RE: **#06ITB49977K-RS, Southwest Arts Center**

Addendum No.1

**SW Arts Phase II Performance Theatre**  
**ITB No. 06ITB 49977K-RS**  
**Addendum 1**  
**6/09/2006**

This Addendum forms a part of and modifies the bidding requirements and proposed Contract Documents for the subject Project, dated **May 8, 2006**. Receipt of this addendum shall be acknowledged on the Bid Form.

PROJECT NAME	PROJECT NO.	DATE	SHEET NO.
FULTON COUNTY SW ARTS PHASE II THEATER	01145	5-30-06	SK27
SHEET TITLE	REF. SHT.	REVISION	SCALE
FINISH PLAN	F1	Addendum 1	1/8"=1'-0"

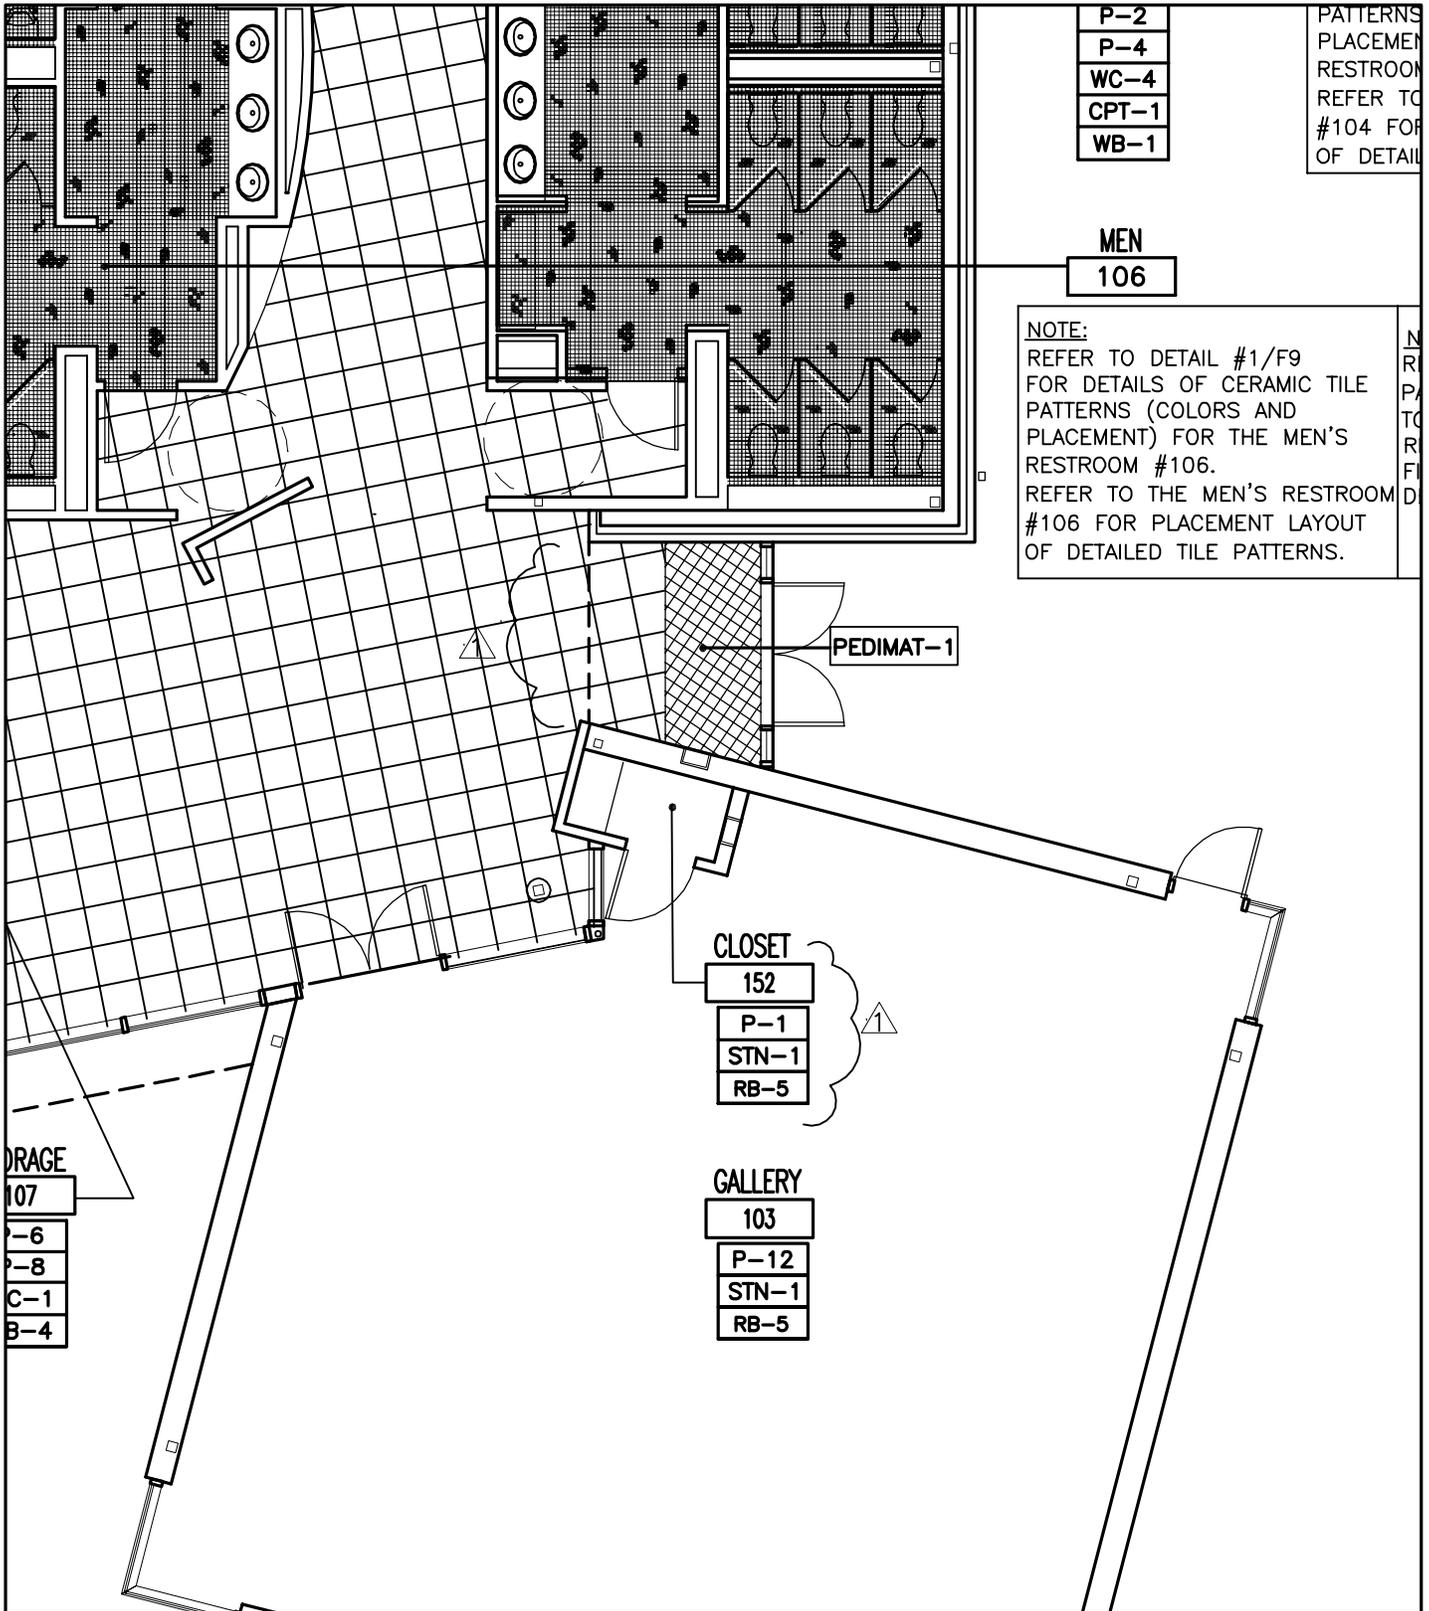
- Add camera floor box plate details
28. Issue SK-27:
  - Clarify floor finish at door 009
  - Add finishes for Closet 152

SHEET TITLE  
FINISH SCHEDULE

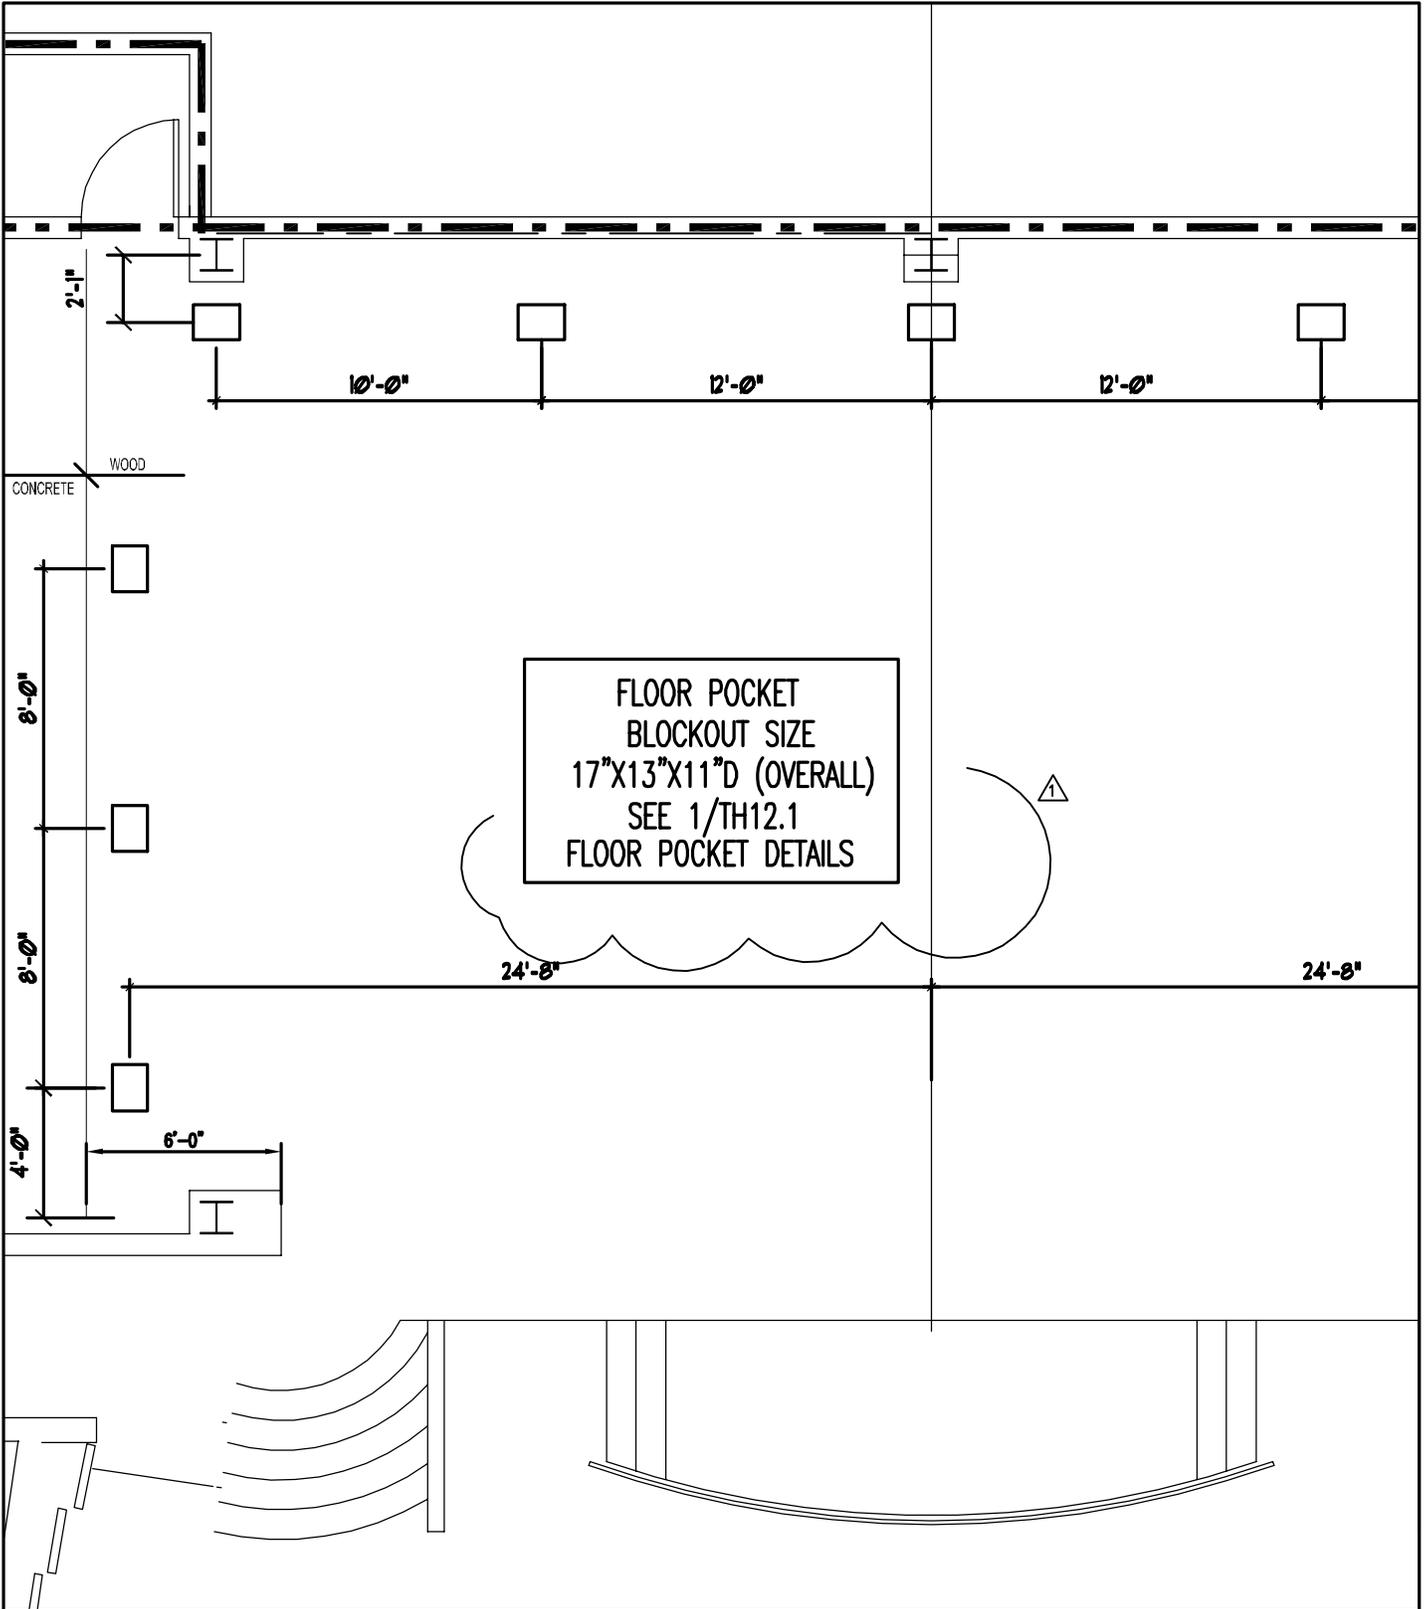
29. Issue SK-28:
  - Revise ceramic tile cove base from D469 Galaxy to D335 Porcelain
30. Issue SK-29:
  - Revise ceramic tile cove base from D469 Galaxy to D335 Porcelain

• SHEET TITLE  
• **Title Sheet**

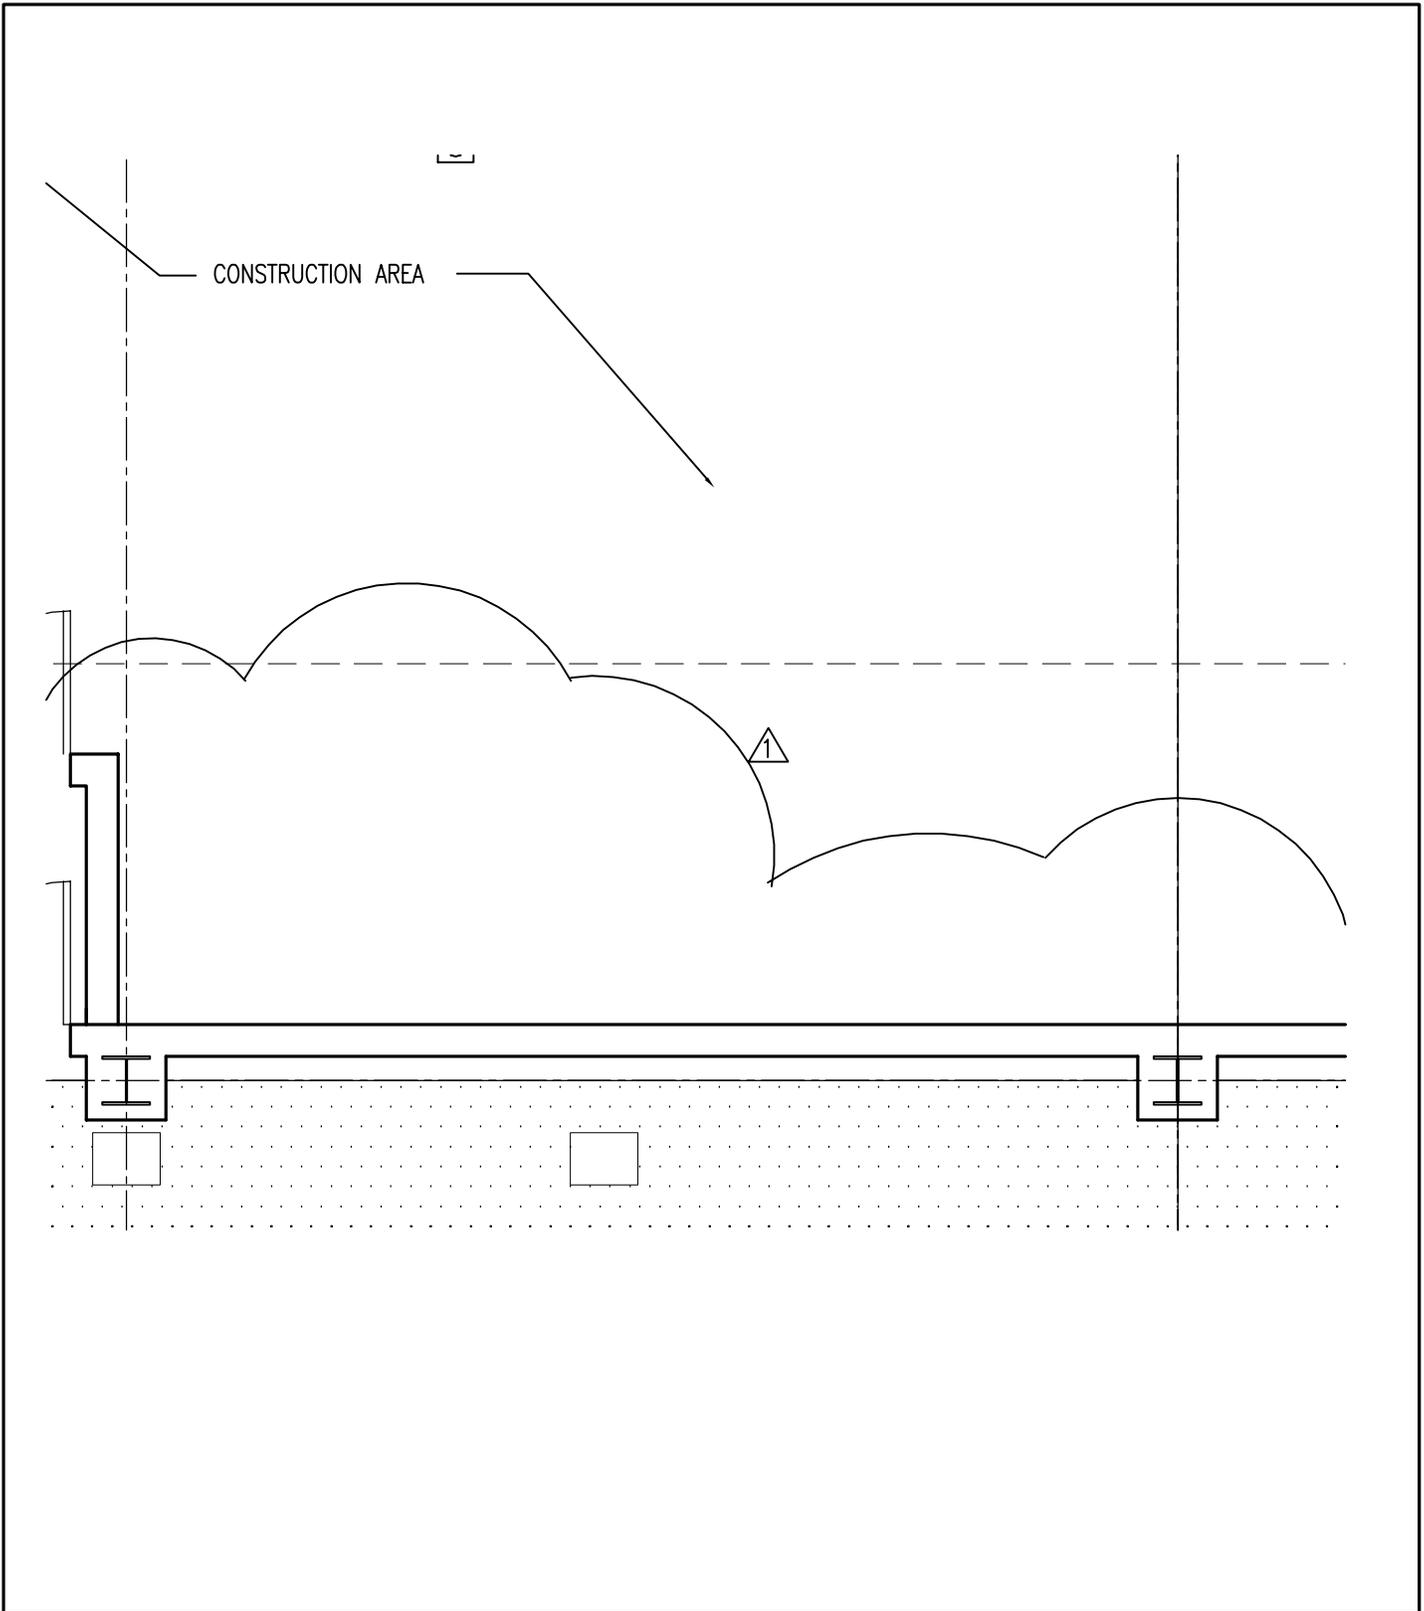
39. **Q:** The cover sheet of the drawings does not include the alternate drawings listed on the MEP  
drawings.  
**A:** Issue SK-32
  - Revise Sheet TO to add drawings M0A, M1A, M2A, M3A, M4A, and M5A to list of  
Mechanical Drawings.

PROJECT NAME	PROJECT NO.	DATE	SHEET NO.
FULTON COUNTY SW ARTS CENTER PHASE II	01145	5-30-06	SK34
SHEET TITLE	REF. SHT.	REVISION	SCALE
ASPHALT PAVING	C10	Addendum 1	N.T.S.

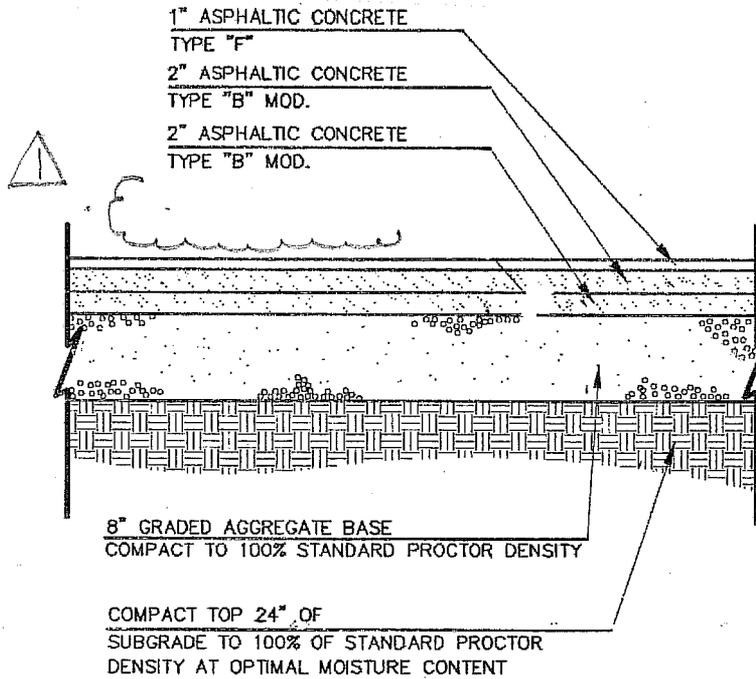
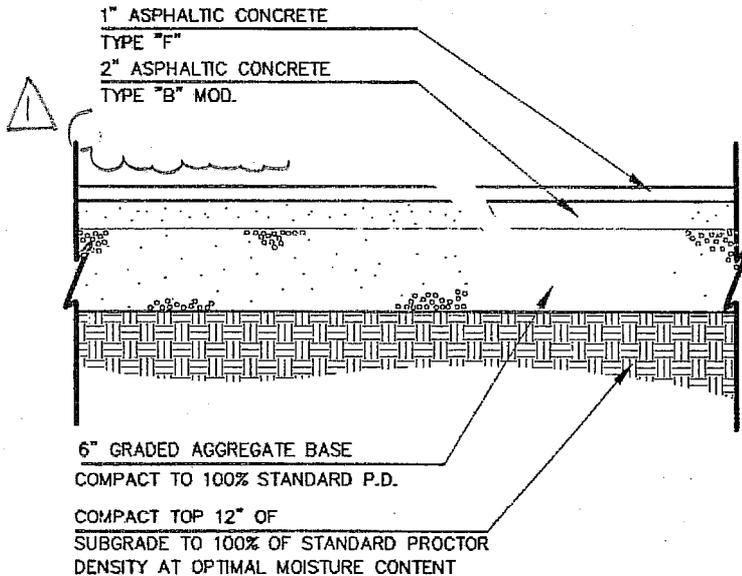
40. **Q:** Please clarify the wall grid located in the scene shop is by owner.  
**A:** Issue SK-33
  - Revise 1/A37 to delete wall grid in scene shop.
41. Issue SK-34

- Revise asphalt paving to delete primer at paving.
42. **Q:** Detail 11/A31 indicates a privacy screen at the dumpster pad per civil drawings. Drawing C1  
indicates a privacy screen per architectural drawings. Please provide details.

SHEET TITLE  
 SCREENING AT  
 MECHANICAL YARD

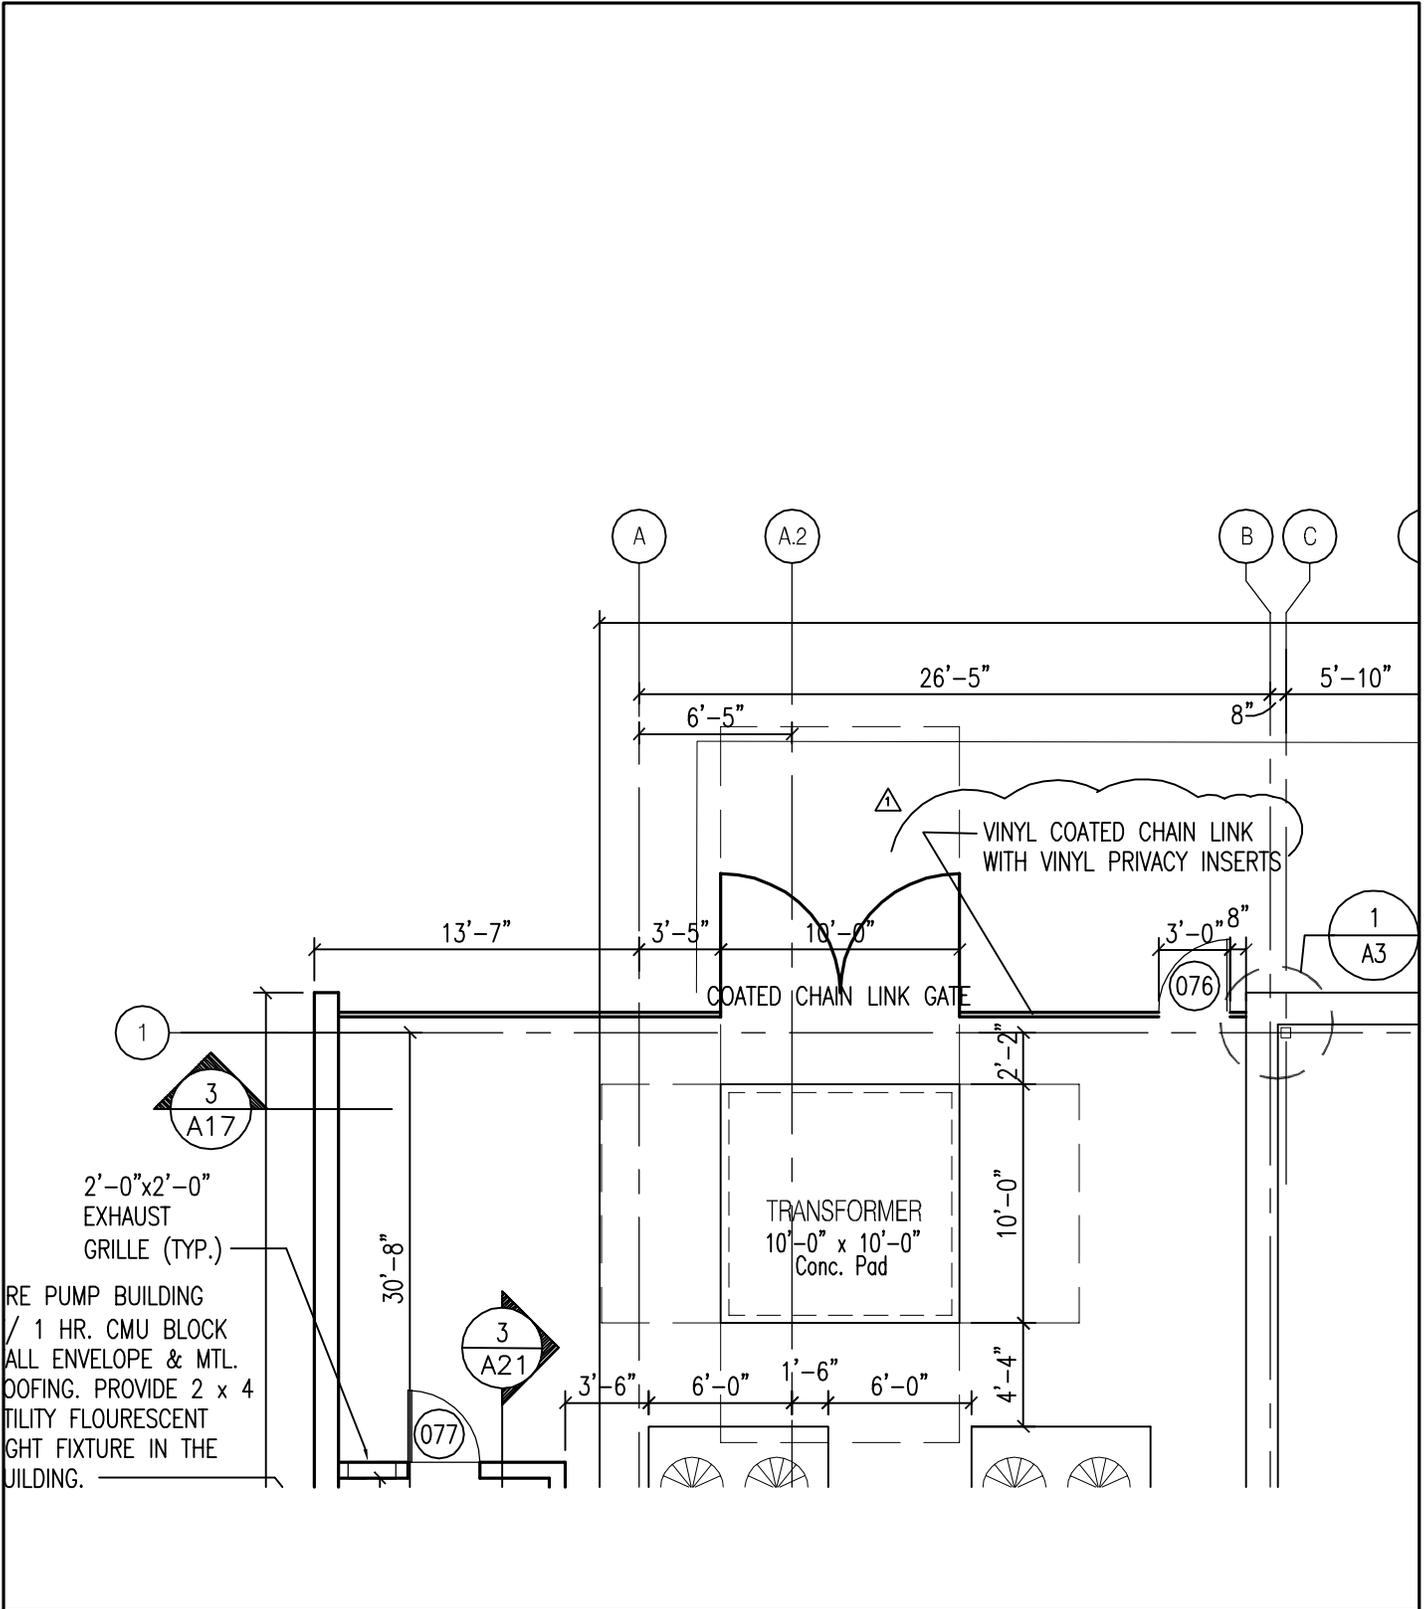
46. Issue SK-36:
- Revise drawing A2 to reduce quantity of brick screen wall at mechanical yard and add vinyl coated chain link fencing with vinyl privacy slat inserts where brick wall deleted.
